MANOR PLANNING & ZONING
COMMISSION MEETING
AGENDA
105 E. EGGLESTON STREET
MANOR, TEXAS 78653
OCTOBER 12, 2016 · 6:30 P.M.

Consideration, discussion, and possible action to approve a Preliminary Plat for Stonewater North Revised Phases 1 – 3, Two hundred thirty-one (231) single family lots on 69 acres more or less, located on FM 973 and Tower Rd. Manor, TX. Agent: Doucet and Associates. Owner: Continental Homes of Texas.

RE: Revised Stonewater North Subdivision: Preliminary Plan

Reference: Shadowglen Phase 2, Sections 17, 18, 21A, 21B, 24A & 24B Preliminary Plan

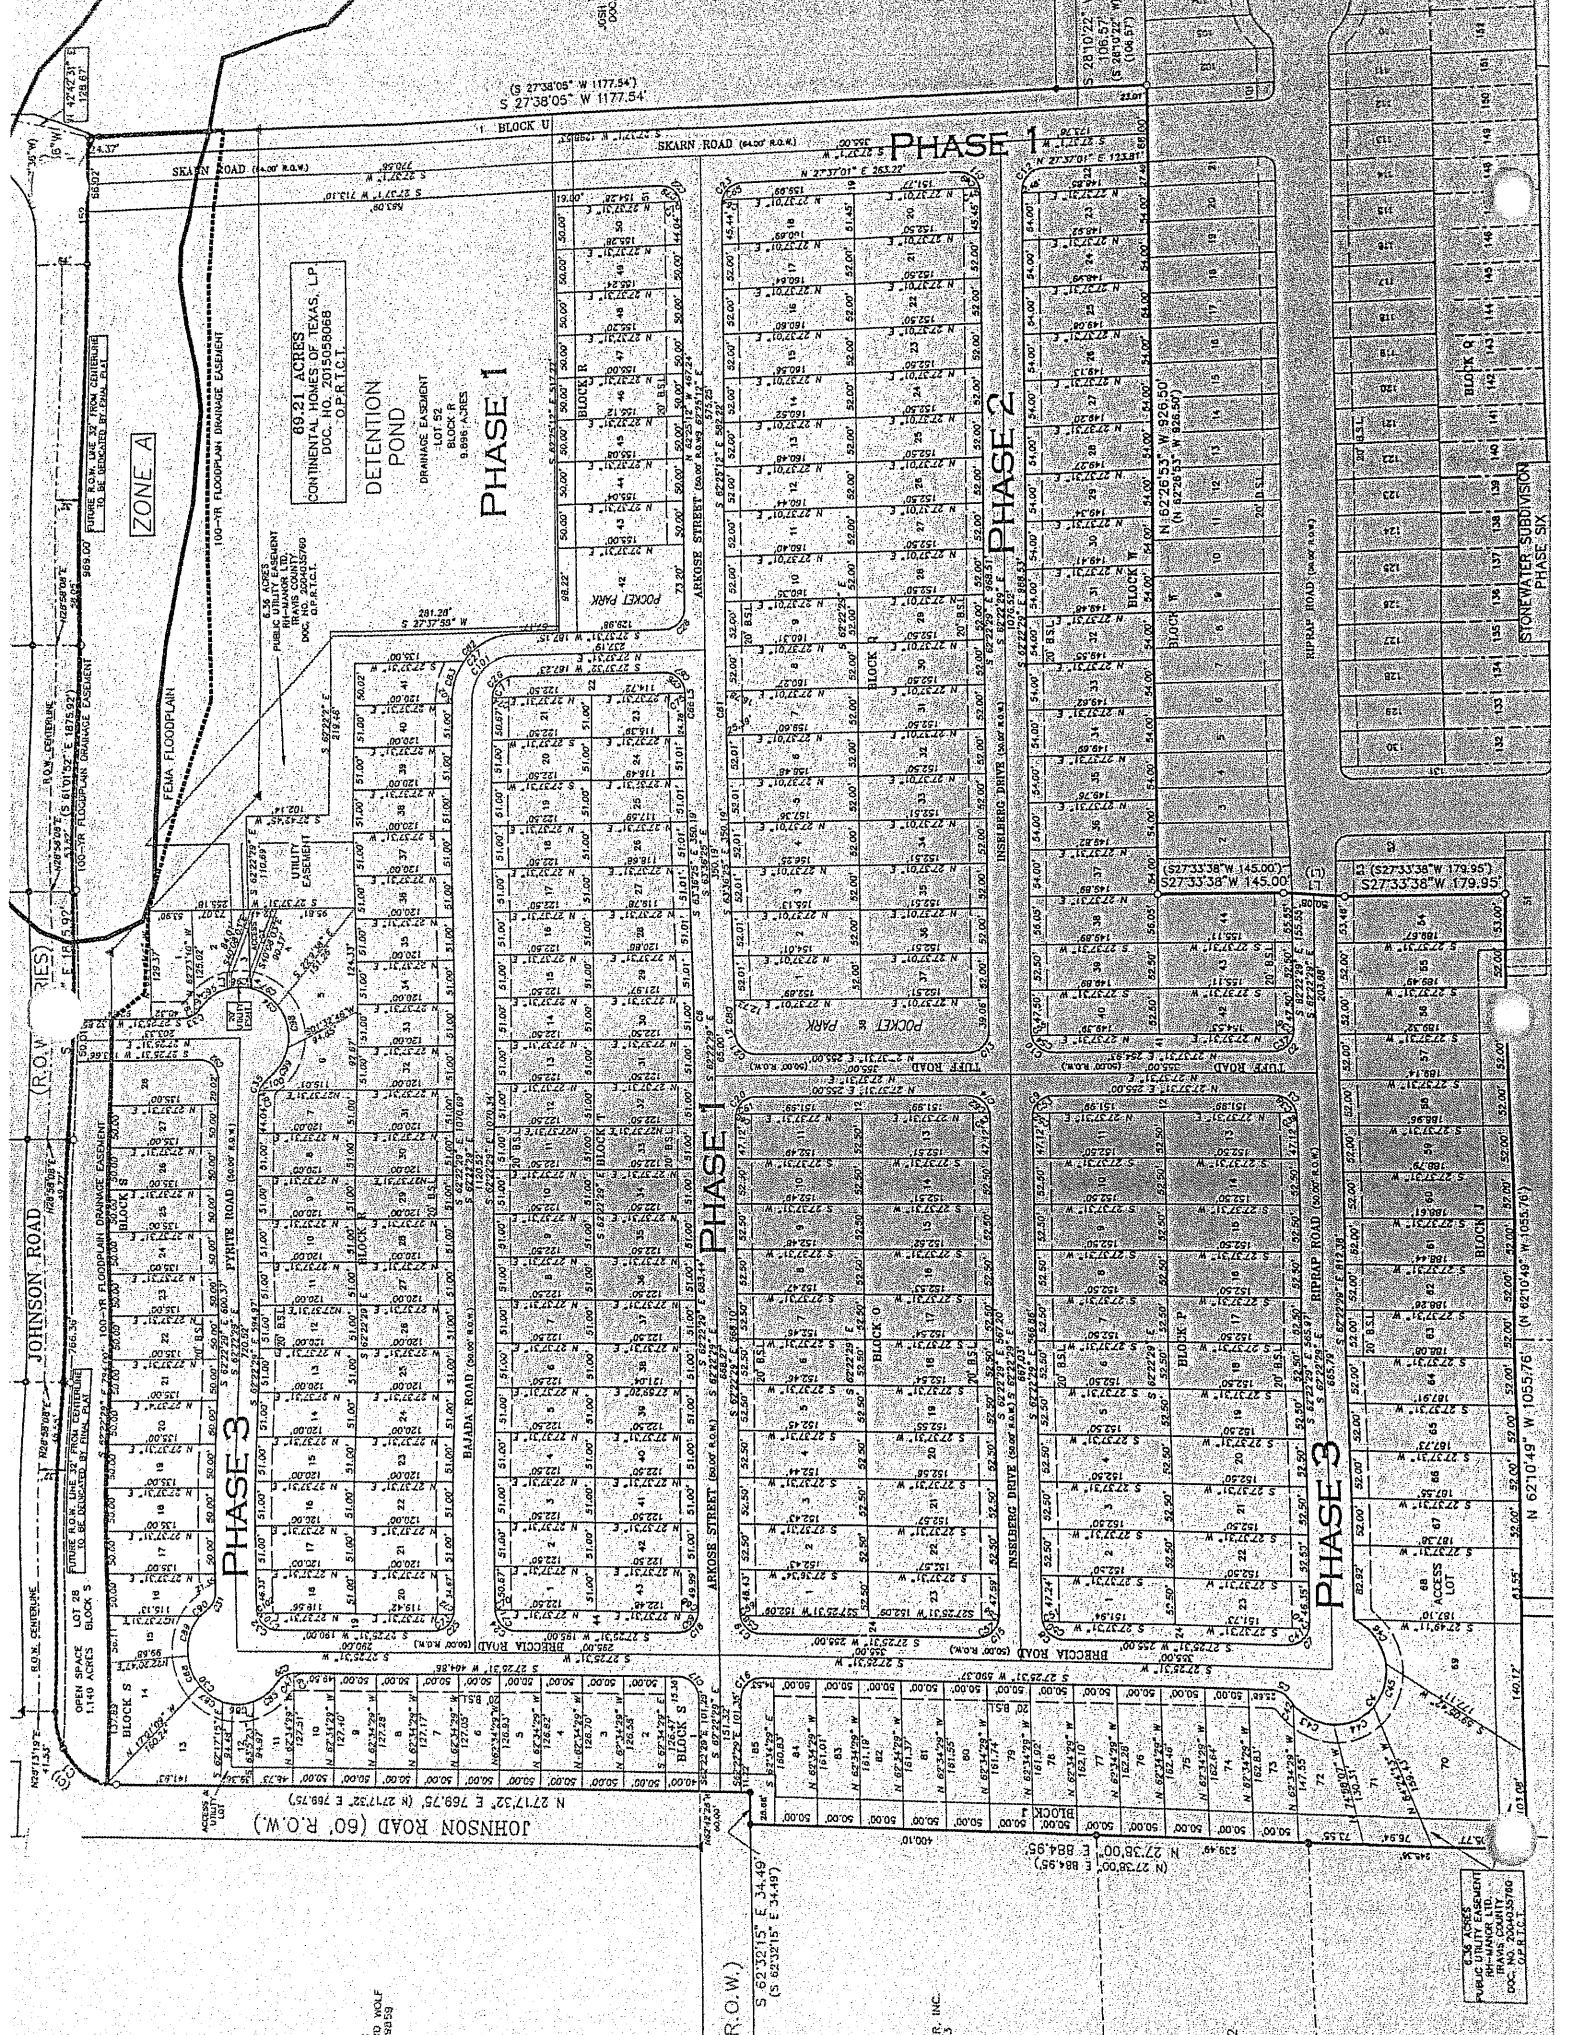
- 3. Arkose Road should be stubbed out to the east to the adjacent property. The stubout is not shown on Sheet 2 – Stonewater North Preliminary Plat.**

- 4. The alignment of Skarn Road should be revised to provide for a smoother tie in at the proposed intersection with Johnson Road. It appears the only change to the alignment was changing the R.O.W. and pavement widths.**

11. Lot 87 on Block J is no longer open space due to the existing road no longer being removed with the proposed project. It should be reclassified.
12. The proposed access road to Rose Hill Cemetery has been removed from the plans. This access road was proposed to bring better access to the cemetery via Stonewater North. Written approval from the Rose Hill Cemetery Association stating that no longer providing the new access road for the cemetery is okay with the Rose Hill Cemetery Association is required.
